Access Compliance Report

Public Rights-of-Way

(Curb Ramps)

Intersection ID: 15258	Main Street: ARDSLEY_RD	Cross Street: HARVARD_PL	Location: SW
ADA ID: 3D3D21E0D146	Ramp Type: BlendTrans1	Initial Pass/Fail: Fail	Overall Compliance: No
		Severity Score: 21.25

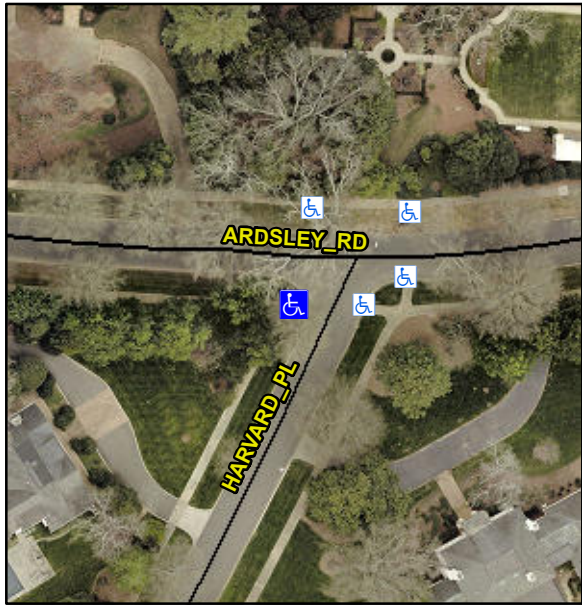
Codes/Mitigation Info/Possible Solution			Field Measurements/Component Compliance					
	Possible Solutions:		Compliance	Description	Data	Compliance	Description	Data
	Remove & Replace Curb Ramp With Two New Directional Ramps or Equivalent.		N/A	Ramp Length (in)	46.0	Yes	BlendTrans Slope (%)	2.9
			No	Ramp Width (in)	46.0	No	BlendTrans XSlope (%)	5.5
			N/A	Flare Type LT	N/A	N/A	Flare Type RT	N/A
			N/A	Flare Slope LT (%)	N/A	N/A	Flare Slope RT (%)	N/A
			N/A	Flare Traversable LT?	N/A	N/A	Flare Traversable RT?	N/A
			N/A	Landing Length (in)	N/A	N/A	DWS Provided?	N/A
			N/A	Landing Width (in)	N/A	N/A	DWS Contrast?	N/A
			N/A	Landing Slope (%)	N/A	N/A	DWS Length (in)	N/A
			N/A	Landing X Slope (%)	N/A	N/A	DWS Full Width?	N/A
Surveyor Notes: N/A			N/A	Landing Curb? (Y/N)	N/A	N/A	DWS Offset (in)	N/A
			N/A	Shared Landing?	N/A			
			N/A	Gutter Ponding?	N/A	N/A	Gutter Slope (%)	N/A
			N/A	Gutter Lip Ht (in)	N/A	N/A	Gutter X Slope (%)	N/A

N/A	Painted X Walk1?	No	N/A	Painted X Walk2?	No
				X Walk 1 Direction	To E		X Walk 2 Direction	To N
				X Walk 1 Width (in)	N/A		X Walk 2 Width (in)	N/A
				X Walk 1 Slope (%)	5.2		X Walk 2 Slope (%)	0.0
				X Walk 1 X Slope (%)	3.3		X Walk 2 X Slope (%)	1.2
			N/A	Ramp inside XWalk1?	N/A	N/A	Ramp inside XWalk2?	N/A
PROW/ADA: R304.5.1, R304.5.3				Road Slope (%)	3.2		Clear Space?	N/A
				Road X Slope (%)	5.2	N/A	Clear Space to XWalk (in)	N/A
			N/A	Any Obstructions?	N/A	N/A	Storm Grate/Utility Hazard?	N/A
				Obstruction Type			Storm Grate/Utility Type	
					N/A			N/A
						Yes	Surface Condition? (G/P)	Good
						N/A	Curb Slope (%)	1.0
Total Cost:		\$ 3200.00
